1st Further Information

**Proposed Temporary Warehouse (Excluding Dangerous Goods Godown) with Ancillary Facilities
for a Period of 3 Years and Associated Filling of Land and Pond in “Agriculture” Zone,
Various Lots in D.D. 107 and Adjoining Government Land, Fung Kat Heung, Yuen Long**

(S.16 Planning Application No. A/YL-KTN/1023)

Responses-to-Comments

LAYOUT PLAN

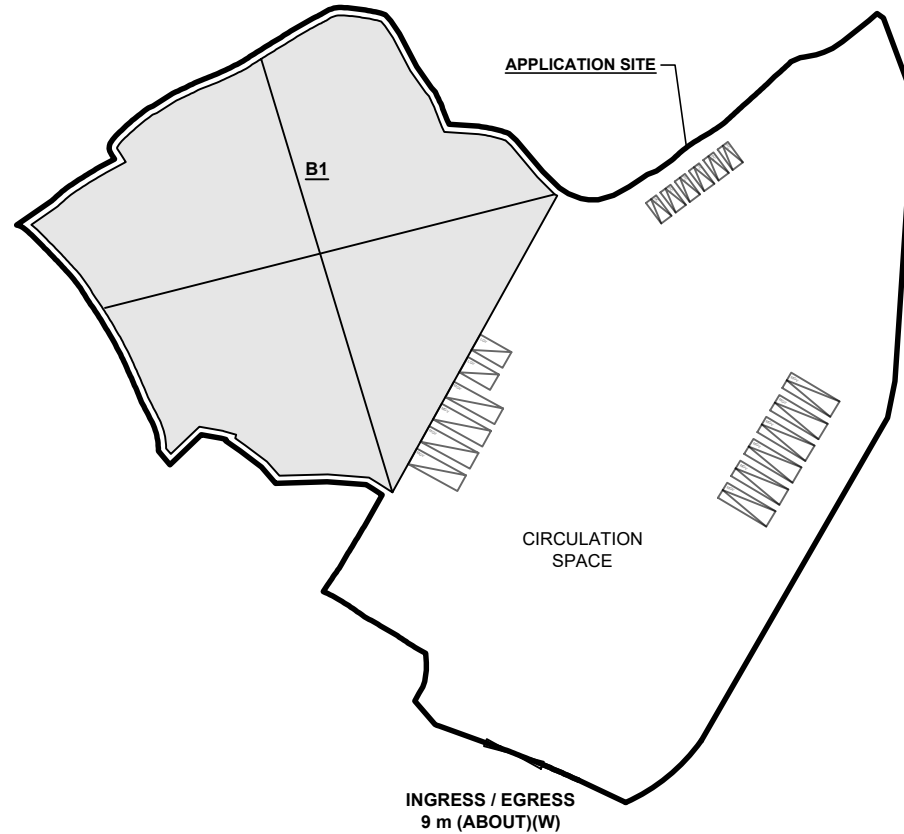
| (a) | <p>According to the proposed layout, the proposed structure, parking space and land filling work maybe in conflict with the existing trees. The applicant shall provide detailed information on the involved tree-felling, and any mitigation measures to be carried out.</p> | <p>A landscape proposal is submitted by the applicant to provide landscape mitigation measures for the proposed development (Annex IV). <u>7</u> new trees (N1 to N7) are proposed to be planted along the southwest periphery boundary of the Site as a landscape buffer to minimise adverse visual impact to the adjoining receivers. All these new trees within the Site will be maintained by the applicant during the planning approval period.</p> |
| (c) | <p>As per the proposed layout and paving plan, the applicant shall justify the use of the open area and the necessity of the proposed filling of land and pond.</p> | <p>Since the applied use mainly involves 'warehouse (excluding dangerous goods godown)' operation, particularly related to logistic and storage activities, often involves large-scale production processes. These operations require adequate open space to accommodate machinery, equipment, parking</p> |

- (i) Revised plans showing the layout, filling of land and swept path analysis of the application site (the Site) are provided (**Plans 1 to 3 and Annex I**).

| | | <p>and loading/unloading facilities, and production lines. Therefore, the Site with a large open area allows for the efficient layout and organization of these components. In addition, the proposed development requires specialized facilities in support of the daily operations (i.e. drainage facilities and fire service installations), having a larger space allows for the incorporation of these specialized facilities to support the operational needs.</p> <p>As heavy loading of structures and vehicles would compact the existing soiled ground and weaken the ground surface, concrete site formation is required to meet the operational needs and that has been kept to minimal for the operation of the proposed development. The applicant will reinstate the Site to a state that is suitable for farming after the planning approval period.</p> |

DRAWING TITLE
 FIRE SERVICES INSTALLATION LAYOUT PLAN-
 G/F LAYOUT PLAN

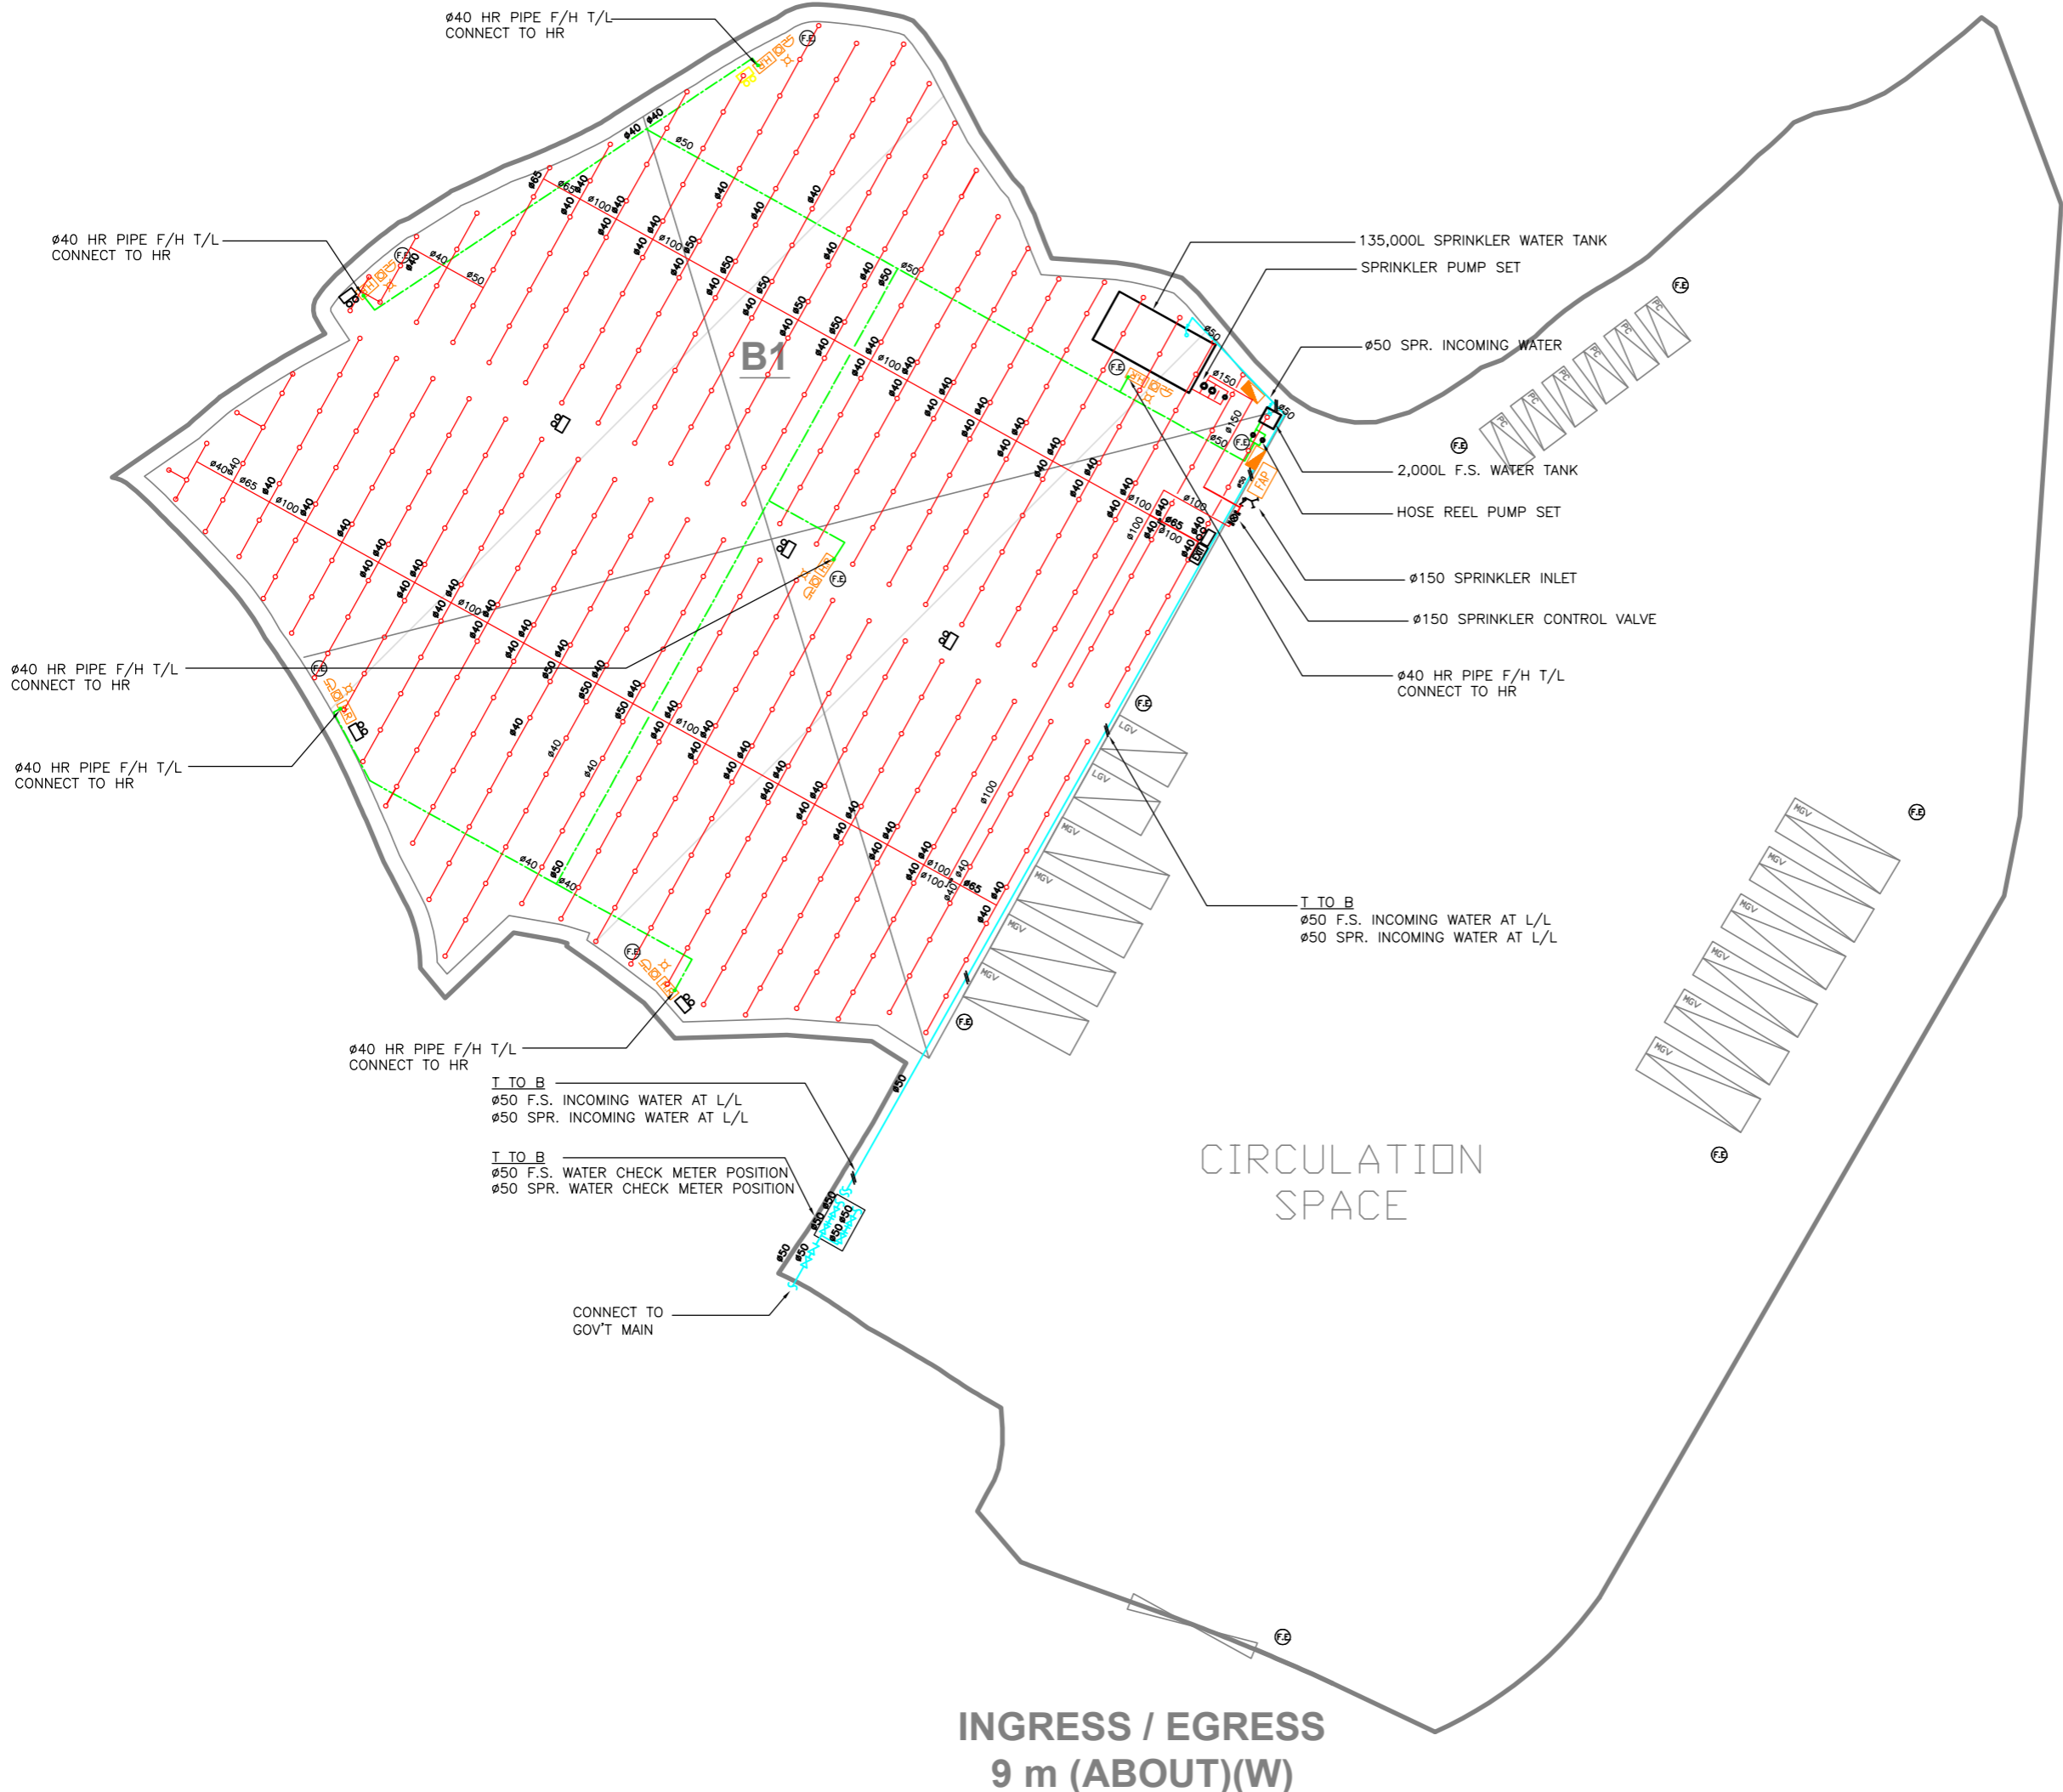
| (a) | <p>Based on the proposed access route, it is noted that the nearest available street fire hydrant is more than 500m away from the application site. In this regard, street fire hydrant system with adequate flow, pressure and size of water tank shall be provided in the site.</p> | <p>A FSIs proposal, with provision of street fire hydrant system with adequate flow, pressure and size of water tank has been provided by the applicant (Annex II)</p> |
| (b) | <p>In consideration of the design/nature of the proposal, FSIs are anticipated to be required. Therefore, the applicant is advised to submit relevant layout plans incorporated with the proposed FSIs to his department for approval. In addition, the applicant should also be advised on the following points:</p> <p>(i) The layout plans should be drawn to scale and depicted with dimensions and nature of occupancy; and</p> <p>(ii) The location of proposed FSIs to be installed should be clearly marked on the layout plans.</p> | |

Title
DRAINAGE LAYOUT PLAN - UNPAVED AREA

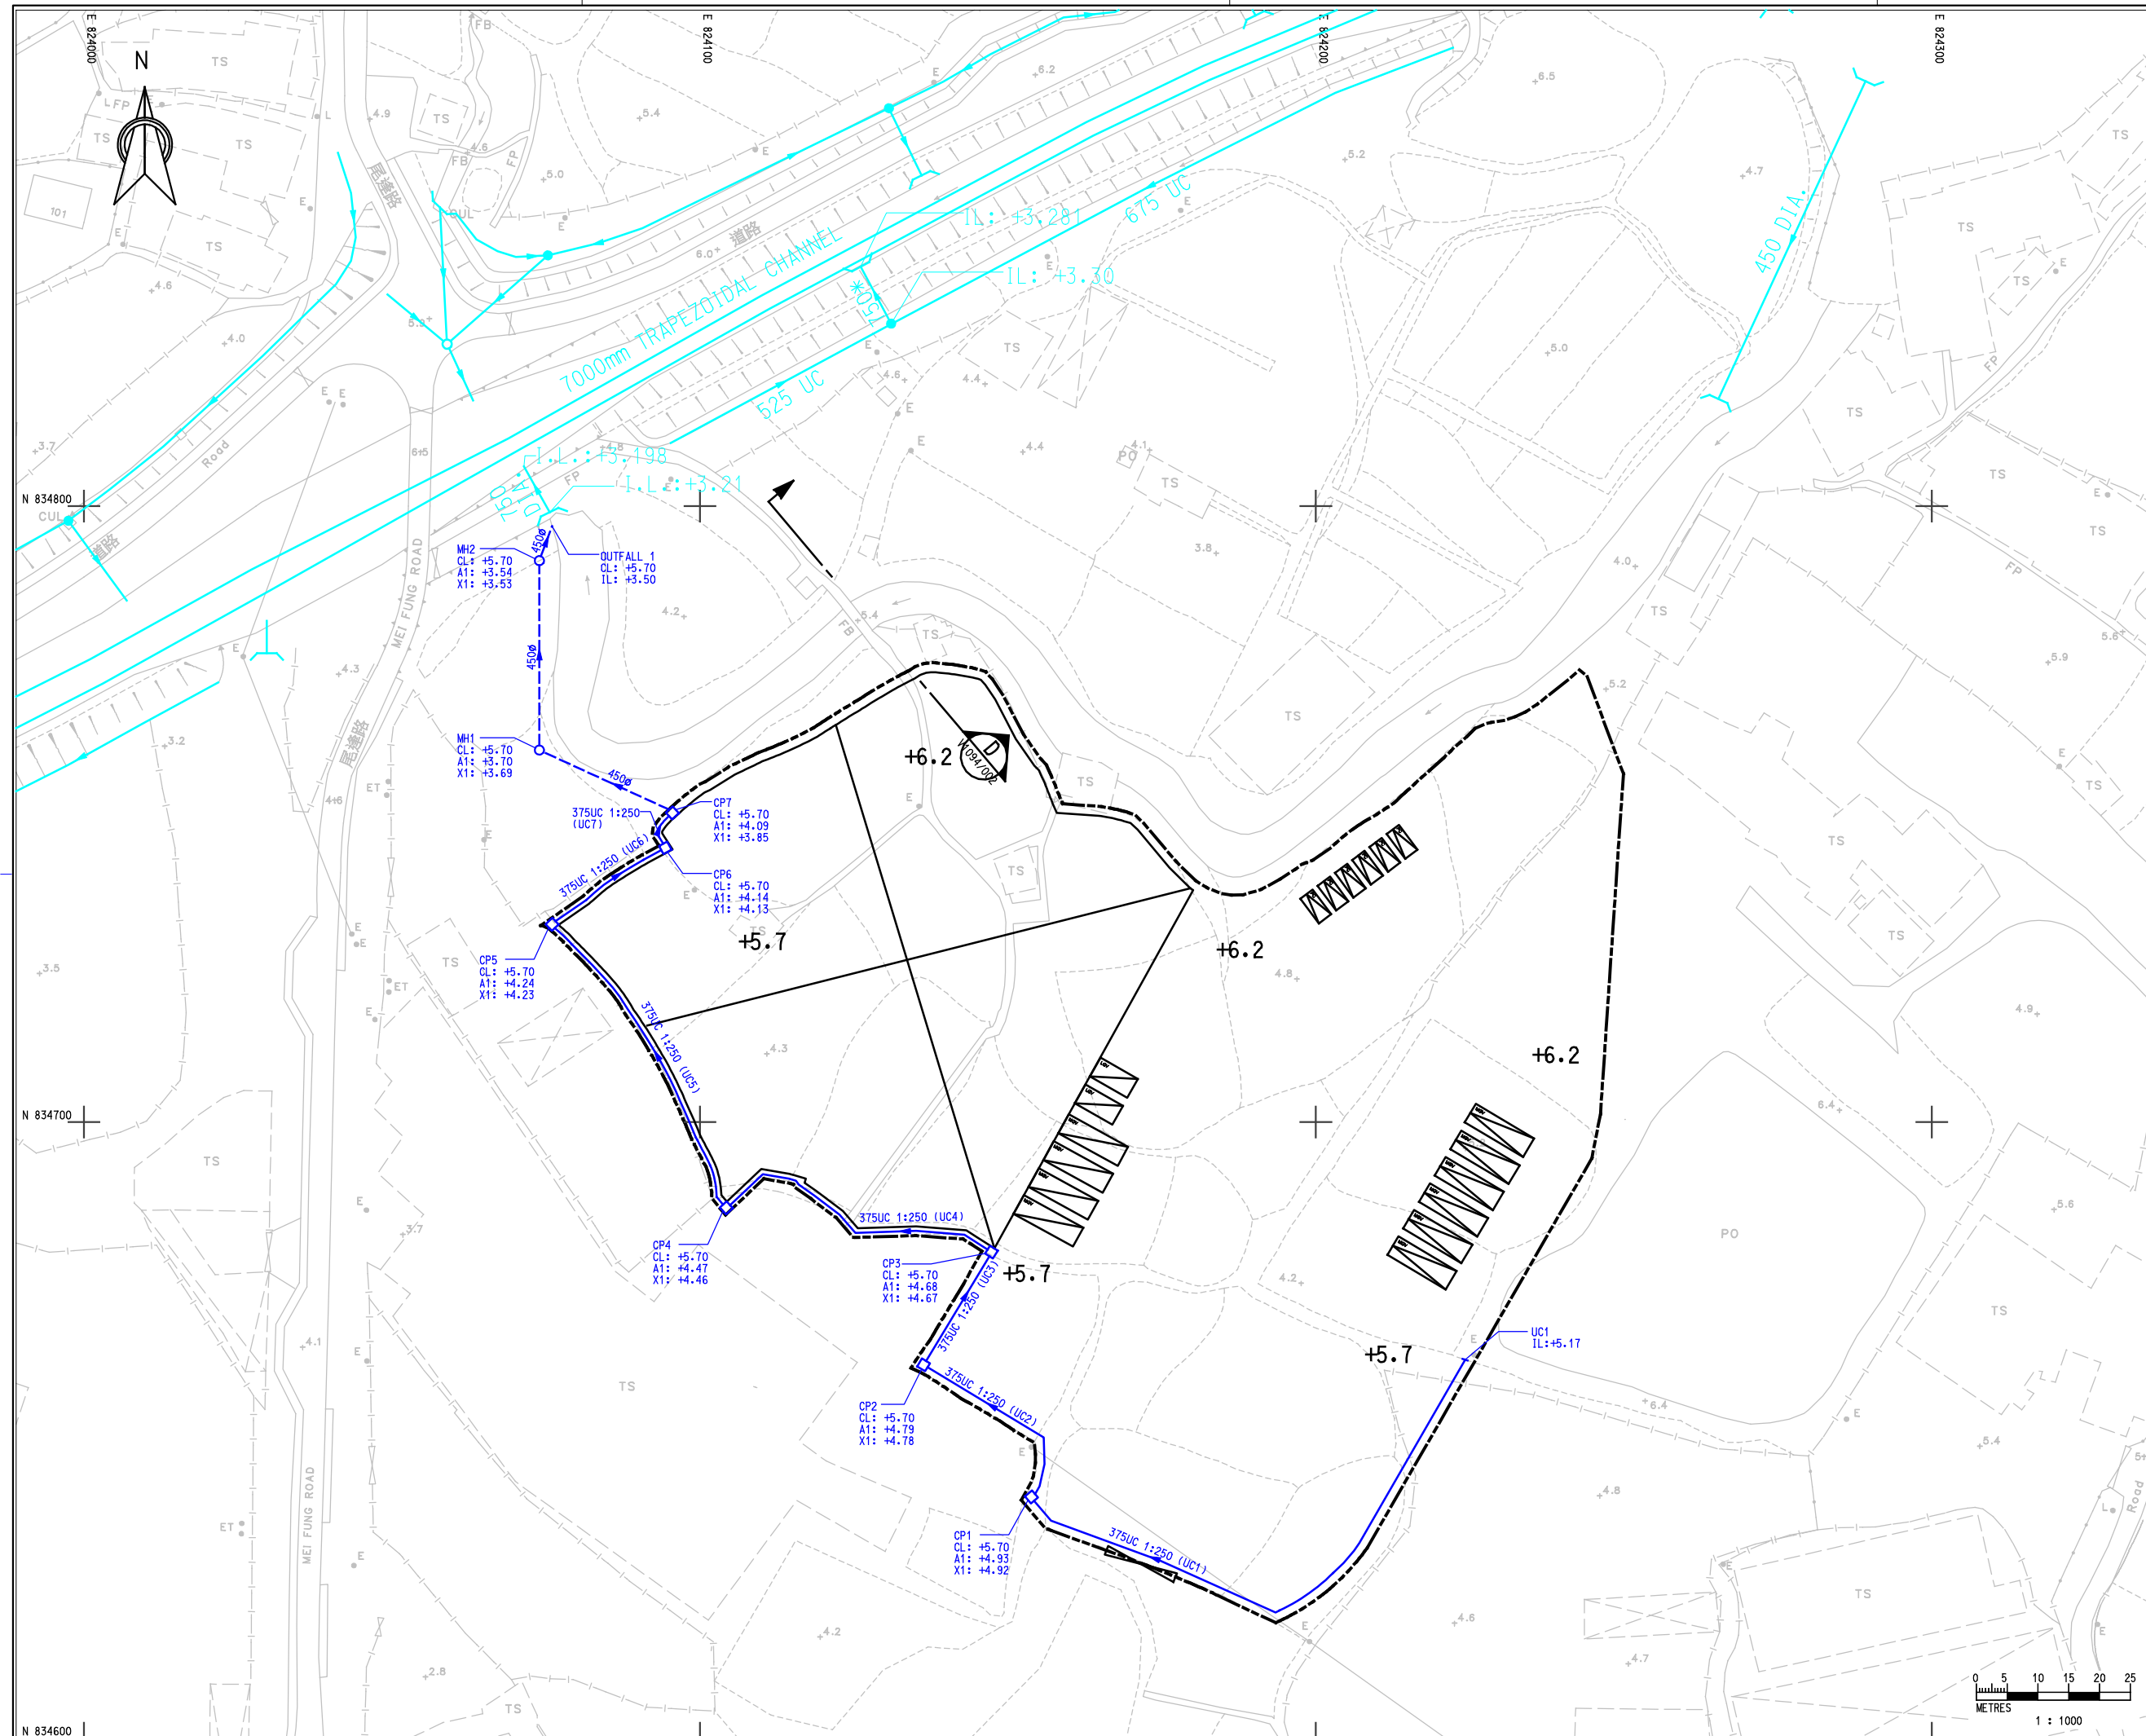
| (a) | <p>Please be advised that a Drainage Impact Assessment (DIA) is required for this application.</p> | <p>A DIA report is submitted by the applicant to review the drainage arrangements for the proposed development (Annex III). The</p> |

| | | <p>proposed filling of land and pond works have already been taken into consideration of the submitted DIA. The increase in surface runoff generated by the proposed development is estimated to be minimal and will be collected by the proposed drainage systems and discharged into the existing drains via the underground pipe. Based on the DIA, it is concluded that <u>no adverse drainage impact</u> is anticipated (Annex III).</p> |

- 4.1 The runoff from the unpaved area in the Site (i.e. Catchment Area Nos. D) would be collected by u-channels and drain to outfall 1 by gravity via 450mm dia. drainage pipes. Drainage layout plan and details of drainage are shown in **Drawing Nos. V1094/003 and V1094/006** in **Appendix A**.

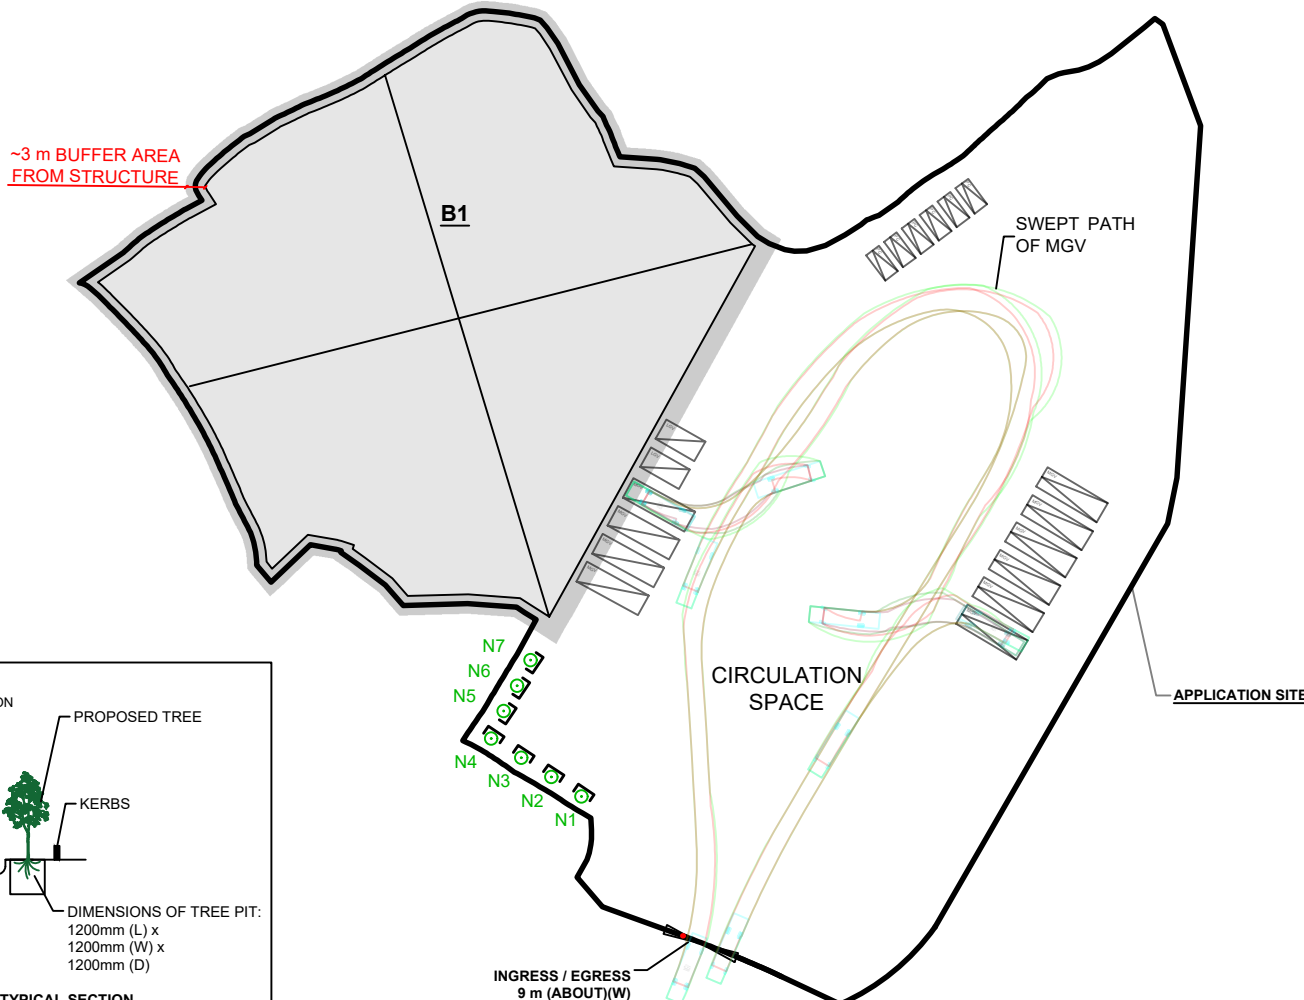
| Departmental Comments | Applicant’s Responses |
|--|---|
| (a) EPD does not support the application as it involves the use of heavy vehicles and there are sensitive uses (i.e. residential buildings) within 100m from the Site, environmental nuisance on the nearby residential uses could be generated by the proposed use. | <p>Fencing will be erected along the whole Site to mitigate potential nuisances to the surrounding areas. Restricted operation hours (i.e. from 09:00 to 19:00 Monday to Saturday, no operation on Sunday and public holiday) will take place at the Site during the planning approval period.</p> <p>The proposed warehouses are intended for storage of miscellaneous goods. No dangerous goods and workshop activities will be stored/conducted at the Site at any time during the planning approval period.</p> <p>A landscape proposal is submitted by the applicant to provide landscape mitigation measures for the proposed development (Annex IV). <u>7</u> new trees (N1 to N7) are proposed to be planted along the southwest periphery</p> |

- NOTES:**
- 1) THE APPLICANT WILL MAINTAIN TREES IN GOOD CONDITION DURING THE PLANNING APPROVAL PERIOD.
 - 2) THE APPLICANT WILL REPLACE TREES WHICH ARE DYING OR DEAD DURING THE PLANNING APPROVAL PERIOD.
 - 3) THE APPLICANT WILL PROVIDE ADEQUATE IRRIGATION FOR TREES.
